SERVICE DIRECTIVE BULLETIN

SERVICE NOTE NO. 0004

DATE: May 10, 1968
SUBJECT: Tail Rotor Blade Life - Part No. 28-15100
MODEL: F-28, All Serial Numbers
COMPLIANCE: Before Further Operation of the Helicopter

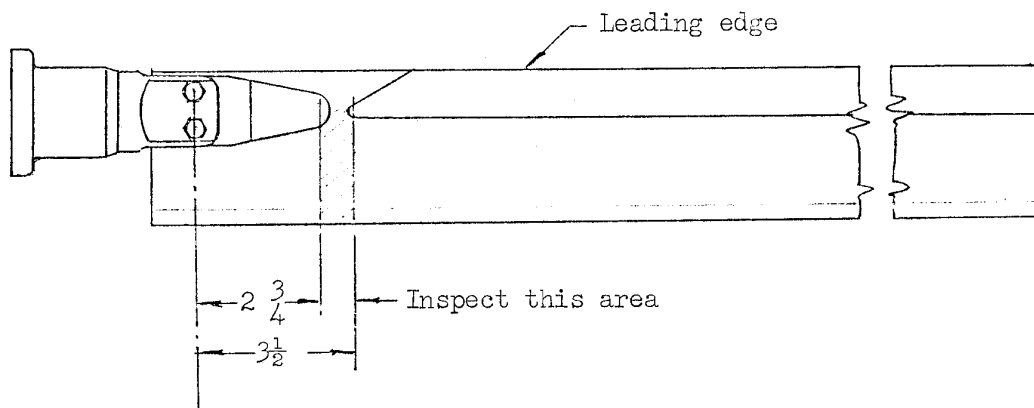
In addition, daily inspection of the blade skin for cracks in the chord-wise direction is required in an area $2 \frac{3}{4}$ to $3 \frac{1}{2}$ inches outboard of the retention bolts. (See sketch)

Should a crack be found, the blade must be retired from service, and we request that the Enstrom Corporation be advised of the defect.
